# UNITED STATES PATENT AND TRADEMARK OFFICE

APPLICATION NO.	FILING DATE	FIRST NAMED INVENTOR	ATTORNEY DOCKET NO.	CONFIRMATION NO.
10/587,153	07/25/2006	Josef Artelsmair	ARTELSMAIR ET AL 8 PCT	4970
25889 7590 03/18/2009 COLLARD & ROE, P.C. 1077 NORTHERN BOULEVARD ROSLYN, NY 11576				
EXAMINER				
DANG, KET D				
ART UNIT		PAPER NUMBER		
4118				
MAIL DATE		DELIVERY MODE		
03/18/2009		PAPER

# Office Action Summary

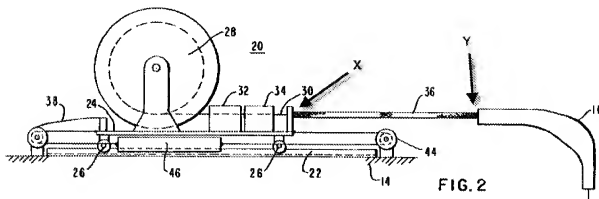
the housing 36 (Fig. 2), wherein one end of the wire core 30 (Fig. 2) is fixed in an end region of the housing Y (Fig. 2 below).

and a measuring means 34 (Fig. 2) is provided to detect the deflection of the wire core 30 (Fig. 2), wherein the wire core is displaceable mounted in a guide element 24 (Fig. 3) on the opposite end region; and two coupling mechanisms X/Y (Fig. 2 above) for connection with a wire guide hose for the wire core 30 (Fig. 2) are arranged on the housing 36 (Fig. 2).
